# **The Great Grid Upgrade** Norwich to Tilbury Environmental Implications of Change – Essex 2 February 2025

AENC-ARC-CNS-REP-0013

## 1. Environmental Implications of Change – Essex 2

#### **Image 1: Proposed Change**

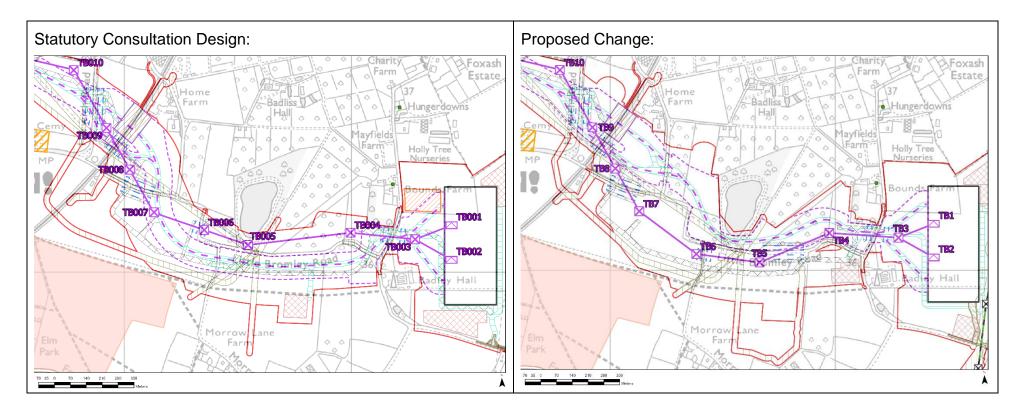
- 1.1.1 This Environmental Implications of Change document should be read alongside the associated Essex 2 targeted consultation leaflet.
- 1.1.2 Image 1 presents the Statutory Consultation design and the proposed change together with key environmental constraints using the key below.

Hydrology, Land Drainage and Flood Risk	The proposed change moves construction works for the overhead line further away from a lake. However, there would be no change to the type or significance of hydrology, land drainage and flood risk effects as a result of the proposed change, when compared to the design and PEIR presented at statutory consultation.
Landscape and Visual	The proposed change would introduce an additional angle tower compared to the design presented at statutory consultation. There would be an additional crossing of the minor road network and the overhead line alignment would be closer to properties to the south along Morrow Lane. Vegetation loss and effects on recreational receptors at the lake would be reduced slightly compared to the design presented at statutory consultation. In terms of landscape, effects on landscape character are likely to be similar. This is because the design presented at statutory consultation and the proposed change would both introduce pylons into the Bromley Heaths landscape character area.

There would be no change to the type or significance of landscape and visual effects as a result of the proposed change to the overhead line and underground cable alignment, when compared to the design and PEIR presented at statutory consultation
Noise and Vibration	There would be no change to the type or significance of noise and vibration effects as a result of the proposed change, when compared to the design and PEIR presented at statutory consultation.
Socio-economics, Recreation and Tourism	The proposed change moves the overhead line alignment further away from Paxman's Angling Club and likely to have a lower magnitude of adverse impact on the receptor but there would be no change to the type or significance of socio-economic, recreation and tourism effects as a result of the proposed change, when compared to the design and PEIR presented at statutory consultation.
